Dear Mr. [Name]:
Please review and verify the proposed water sewer improvement district boundary shown on the attached map. The map shows the proposed boundary for the 61.4 AM water sewer improvement district. The map also shows the proposed boundary for the 61.4 AM water sewer improvement district. The map also shows the proposed boundary for the 61.4 AM water sewer improvement district.

BEACON VILLAGE - REVISED DRAINAGE PLAN (PARKWOOD SYSTEM TO MAINS GATE)

BEACON VILLAGE
DRAINAGE & UTILITY PLAN

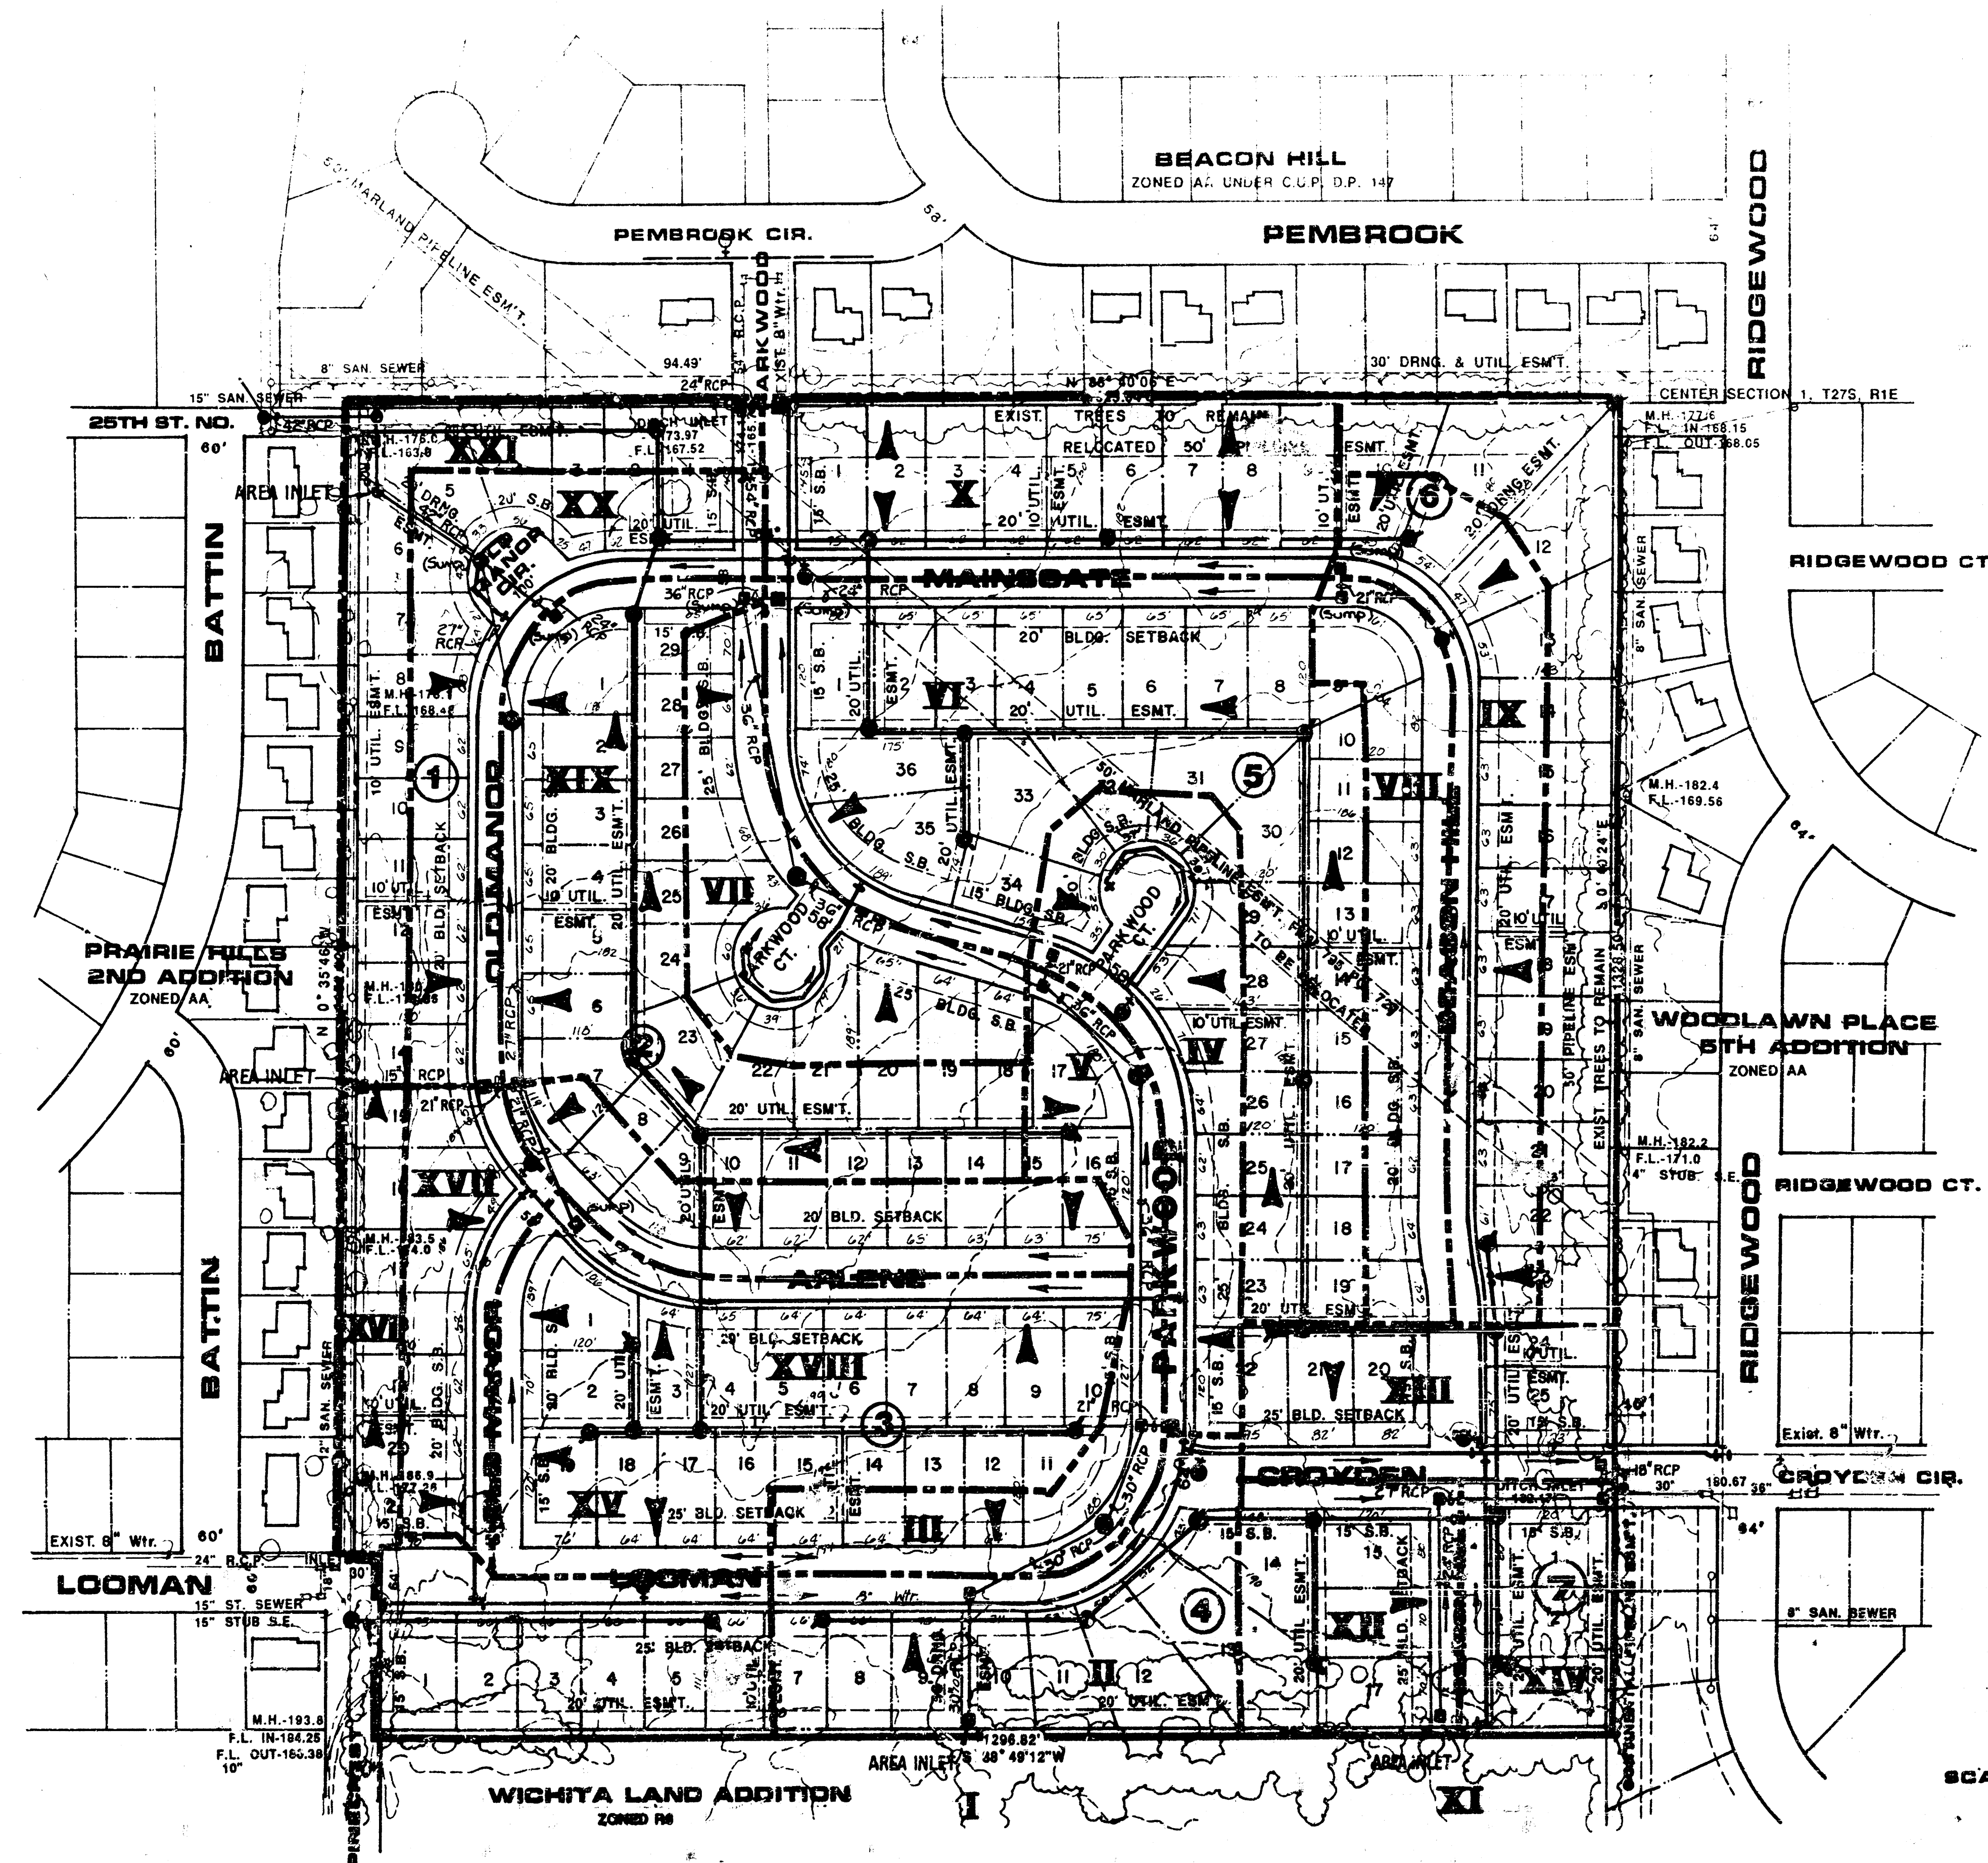
1. Verify the proposed boundary for the 61.4 AM water sewer improvement district. The map shows the proposed boundary for the 61.4 AM water sewer improvement district. The map also shows the proposed boundary for the 61.4 AM water sewer improvement district. The map also shows the proposed boundary for the 61.4 AM water sewer improvement district.

2. Verify the proposed boundary for the 61.4 AM water sewer improvement district. The map shows the proposed boundary for the 61.4 AM water sewer improvement district. The map also shows the proposed boundary for the 61.4 AM water sewer improvement district. The map also shows the proposed boundary for the 61.4 AM water sewer improvement district.

3. Verify the proposed boundary for the 61.4 AM water sewer improvement district. The map shows the proposed boundary for the 61.4 AM water sewer improvement district. The map also shows the proposed boundary for the 61.4 AM water sewer improvement district. The map also shows the proposed boundary for the 61.4 AM water sewer improvement district.

4. Verify the proposed boundary for the 61.4 AM water sewer improvement district. The map shows the proposed boundary for the 61.4 AM water sewer improvement district. The map also shows the proposed boundary for the 61.4 AM water sewer improvement district. The map also shows the proposed boundary for the 61.4 AM water sewer improvement district.
